SIB 61 14 26

SERVICE ACTION: WEATHERPROOF THE REAR FOG LIGHT CONNECTOR

2026-09-09

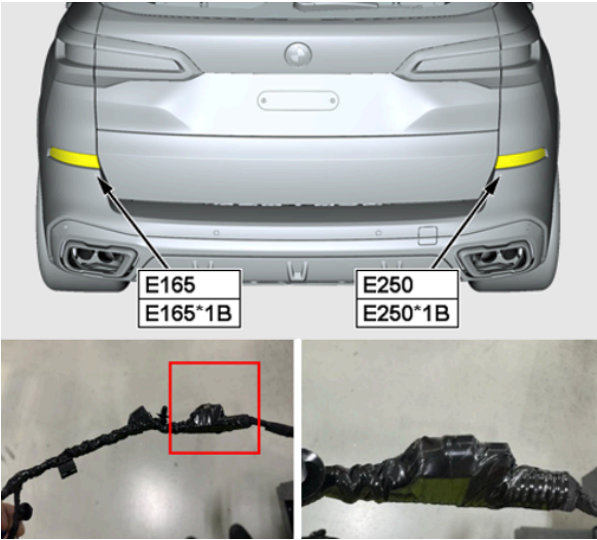
Although the rear bumper is not equipped with a rear fog light, the Park Distance Control (PDC) wiring harness includes an unused fog light connector located in an area exposed to moisture.

During production, the connector was wrapped in black electrical tape, which does not provide sufficient protection against moisture and may allow water to enter the wiring harness.

Expose the rear fog light connector in the PDC wiring harness, then seal both wire ends with an insulating cap to prevent moisture intrusion.

2. On the driver's side, remove the electrical tape from the rear fog light (E165*1B) connector.

3. Expose the connector from the wiring harness.

4. Remove the two pins from the fog light (E165*1B) connector.
